Addendum 01 for RFQ933500-01

Project Name: DPS Oran Pape Intel Ops Room Remodel
DAS RFQ #: 933500-01
DAS Project #: 9335.00
Date: 6/14/2023

FP1.0

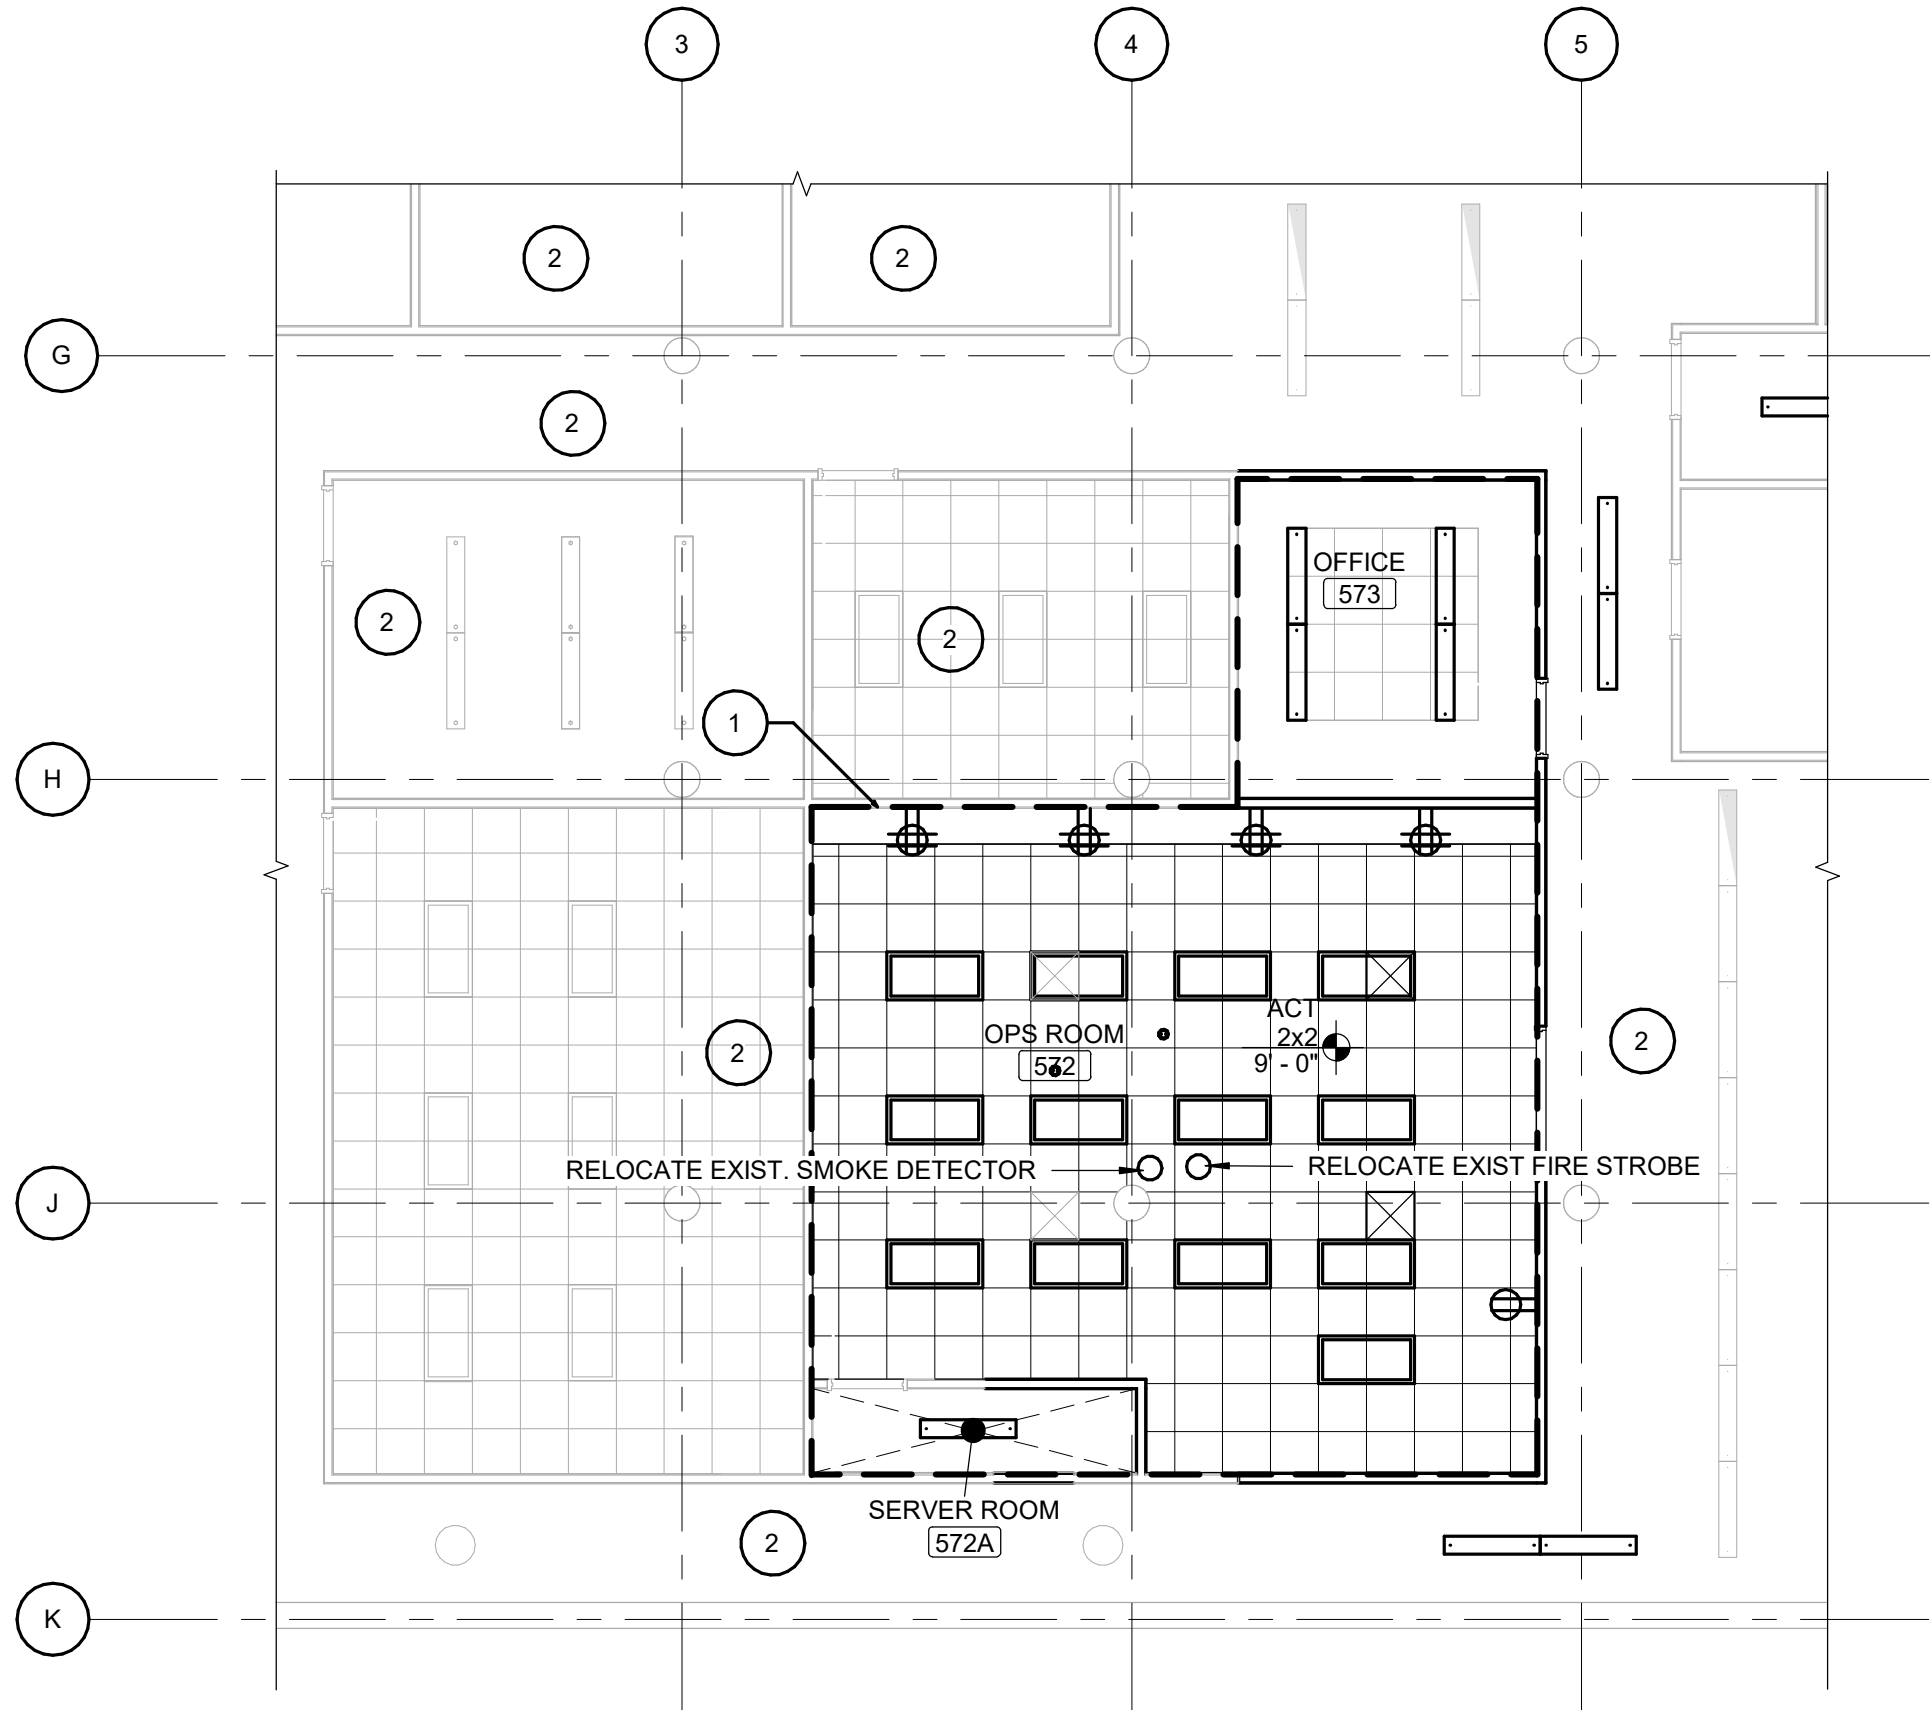
4. **ADD** sheet FP1.0 FIRE PROTECTION

1 FLOOR PLAN
SCALE: 1/8" = 1'-0"

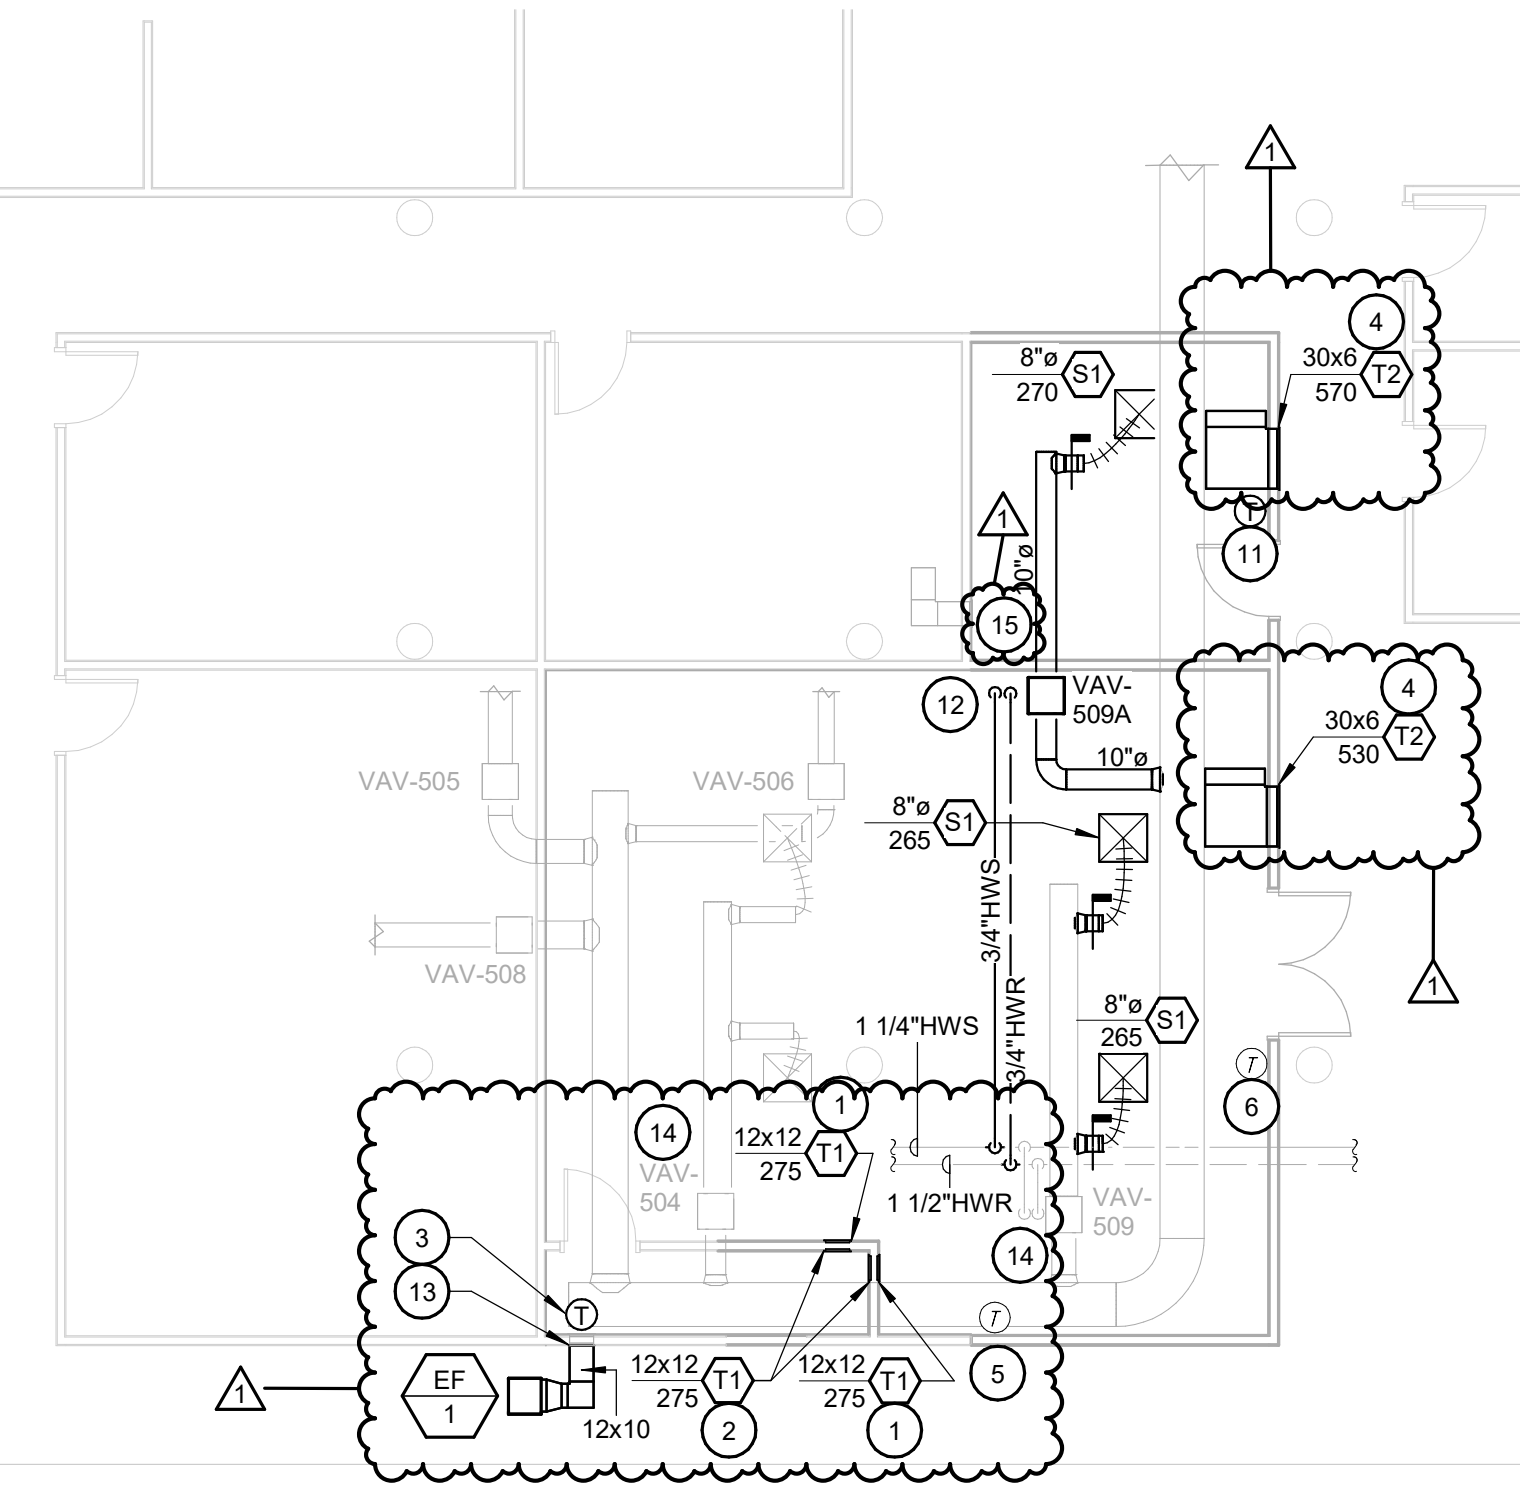
5. **MODIFY** Keynote #1 to read "MOUNT TRANSFER GRILLE 1'-8" ABOVE FINISHED FLOOR."
6. **MODIFY** Keynote #3 to read "FURNISH AND INSTALL NEW EF-1 AND 12"X10" EXHAUST DUCT FROM EXISTING OPENING TO EF INLET, TO BE CONTROLLED BY 120V COOLING THERMOSTAT SET AT 80 DEGREES F."

7. **MODIFY** Keynote #4 to read "MOUNT TRANSFER GRILLE 10'-0" ABOVE FINISHED FLOOR. FURNISH AND INSTALL LINED TRANSFER DUCT ELBOW."
8. **ADD** Keynote # 13 to read "REMOVE AND DISPOSE OF EXISTING TRANSFER GRILLE AND SMOKE DAMPER."

9. **ADD** Keynote # 14 to read "MODIFY THE MINIMUM POSITION OF VAV-504 TO 215 CFM AND THE MINIMUM POSITION OF VAV-509 TO 335 CFM."
10. **ADD** Keynote # 15 to read "EXISTING TRANSFER GRILLE TRANSFERRING 300 CFM INTO NEW OFFICE SPACE."

11. **ADD** Keyed Note #13 to FLOOR PLAN.
12. **ADD** Keyed Notes #14 to FLOOR PLAN.
13. **ADD** Keyed Note #15 to FLOOR PLAN.
14. **MODIFY** AIR DEVICE SCHEDULE to read MARK T1 as "0.01" MAX. AIR P.D. (IN. W.C.).

17. **MODIFY** AIR DEVICE SCHEDULE to read MARK T2 as "30X6" FACE SIZE.
18. **ADD** EXHAUST FAN SCHEDULE.
19. **MODIFY** FLOOR PLAN to show transfer ducts T2 as 30x6 as shown in AIR DEVICE SCHEDULE.
20. **MODIFY** FLOOR PLAN to show transfer ducts T1 as 12x12 as shown in AIR DEVICE SCHEDULE.
21. **ADD** 30x6 lined transfer duct elbows to FLOOR PLAN.
22. **ADD** new 12x10 ductwork with elbow to FLOOR PLAN.
23. **ADD** new Exhaust Fan EF-1 with equipment tag to FLOOR PLAN.

E2.5

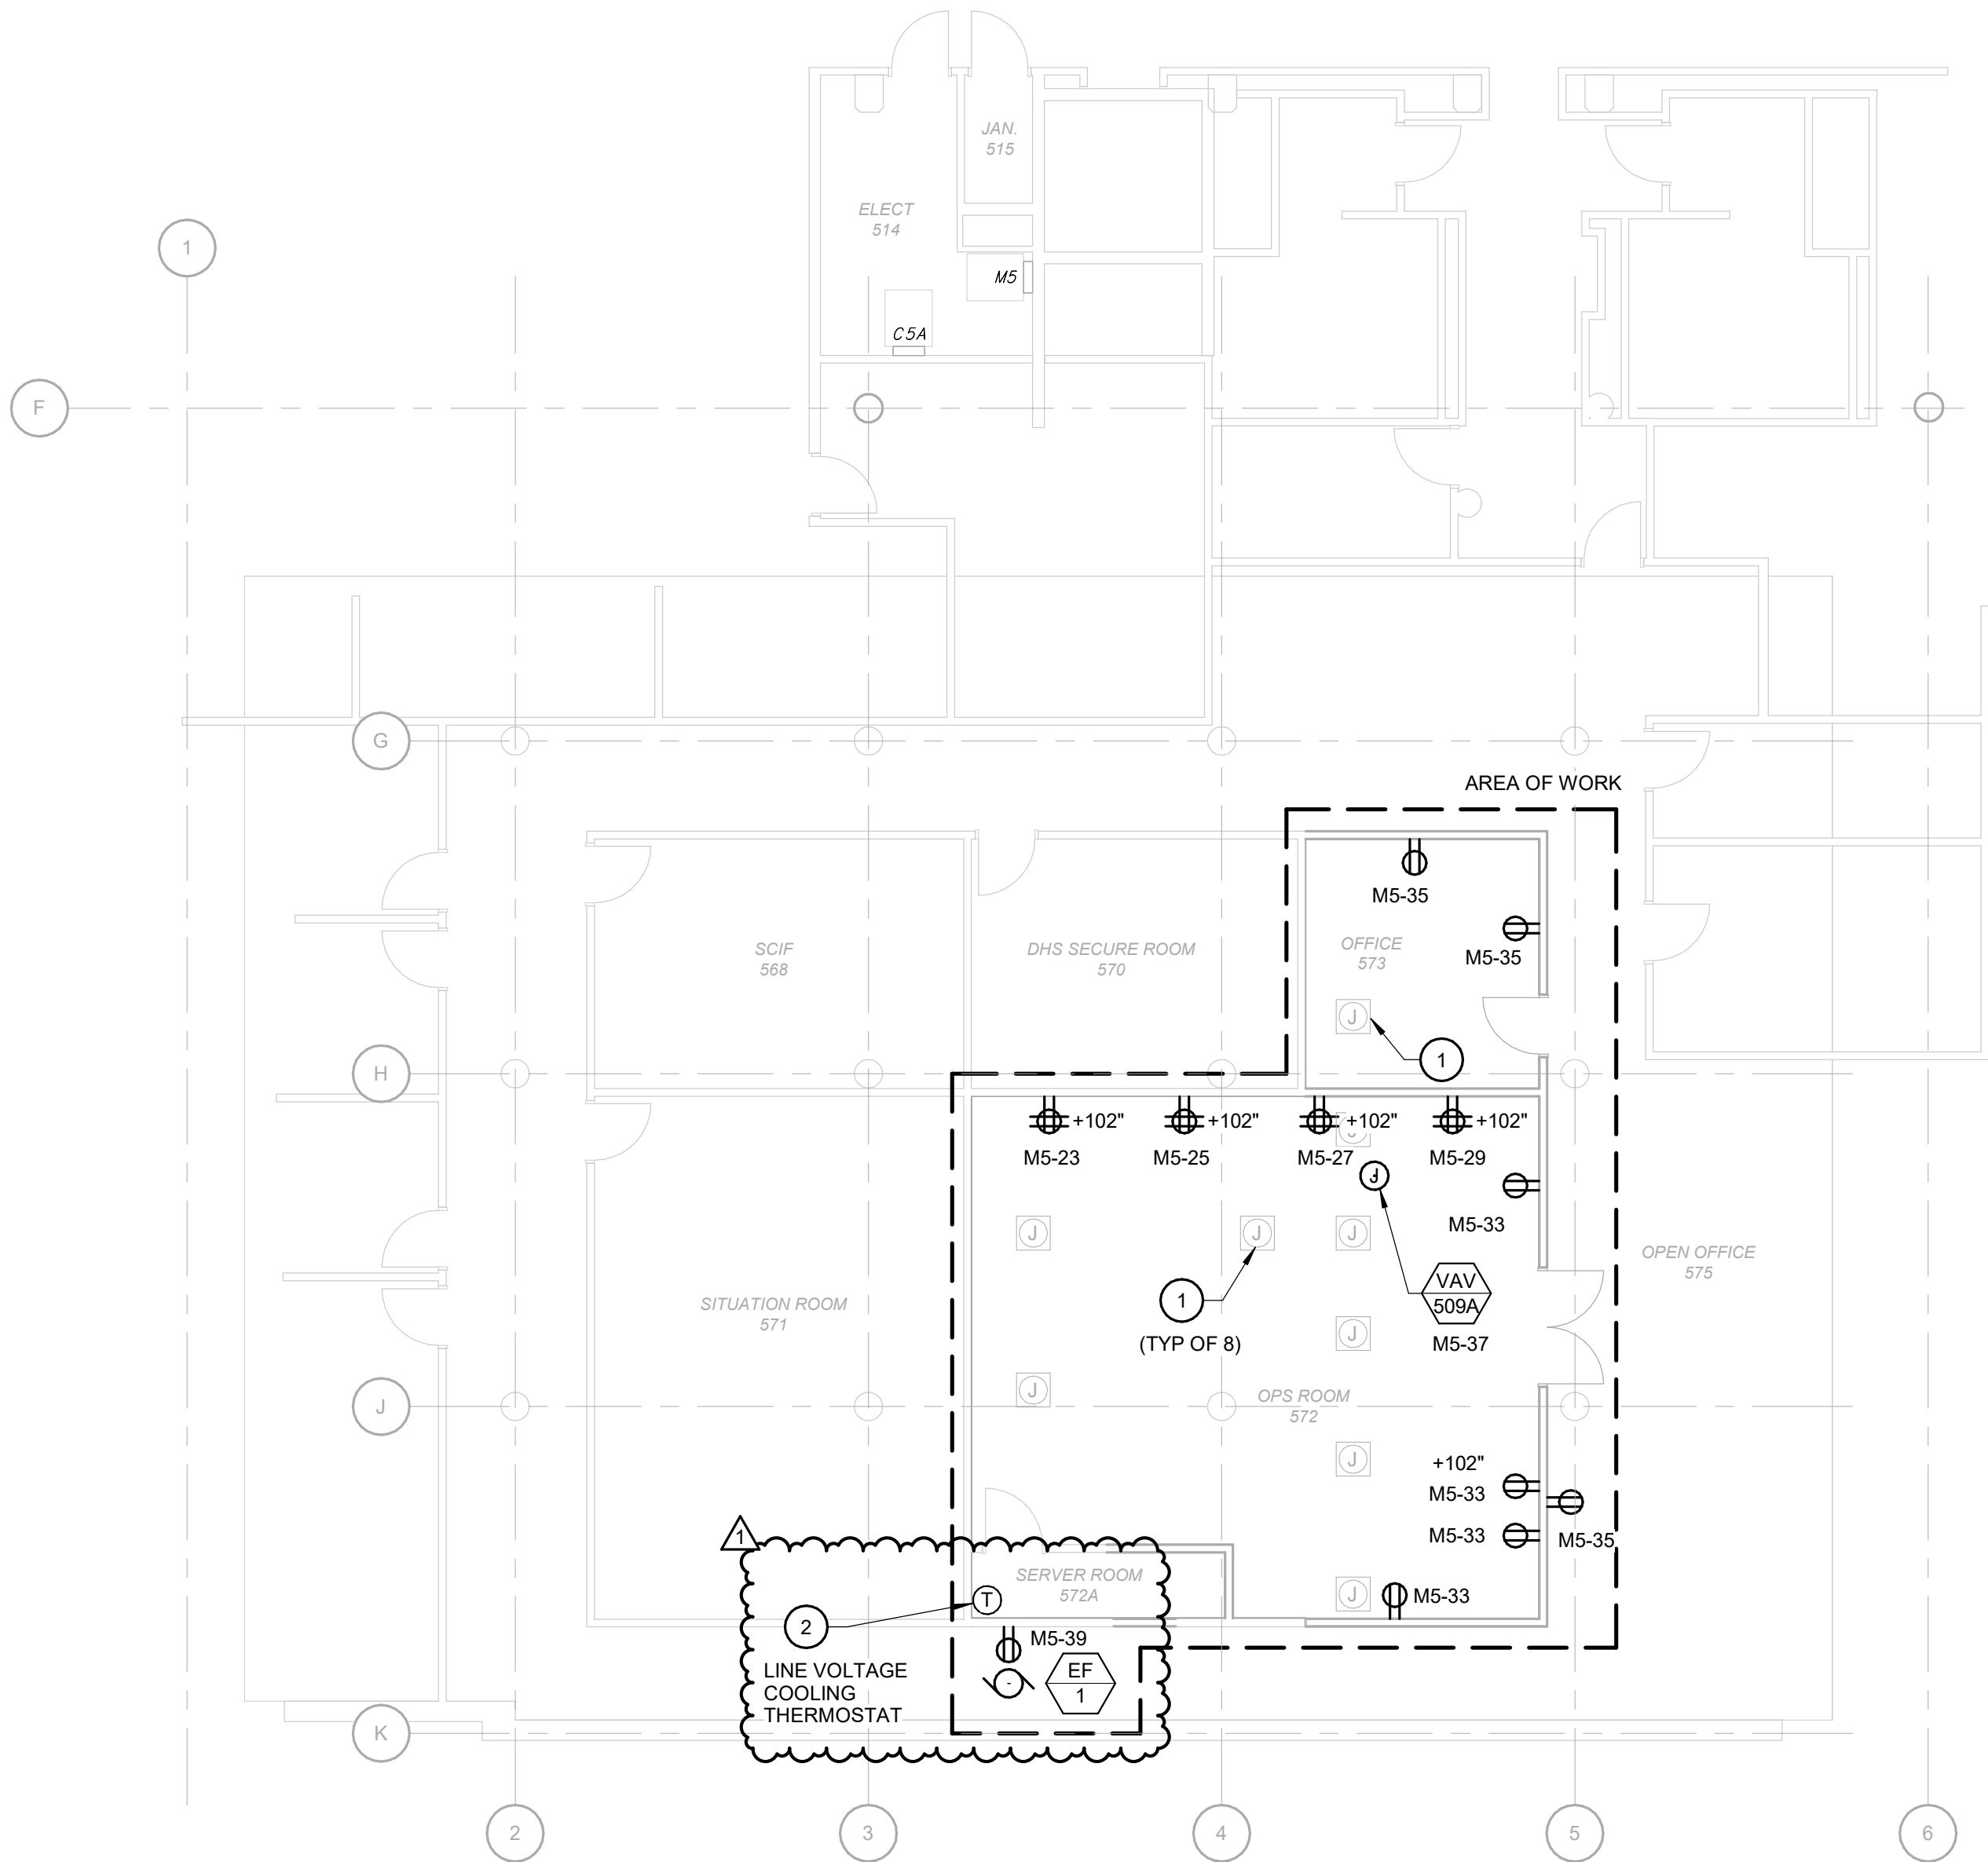
24. **ADD** EF-1 and LINE VOLTAGE COOLING THERMOSTAT to drawing.

- 1
- EXISTING COMBINATION POWER AND DATA FLOOR BOX.
- 2
- ELECTRICAL CONTRACTOR TO INSTALL LINE VOLTAGE COOLING THERMOSTAT TO EF-1. THERMOSTAT PROVIDED BY MECHANICAL CONTRACTOR.
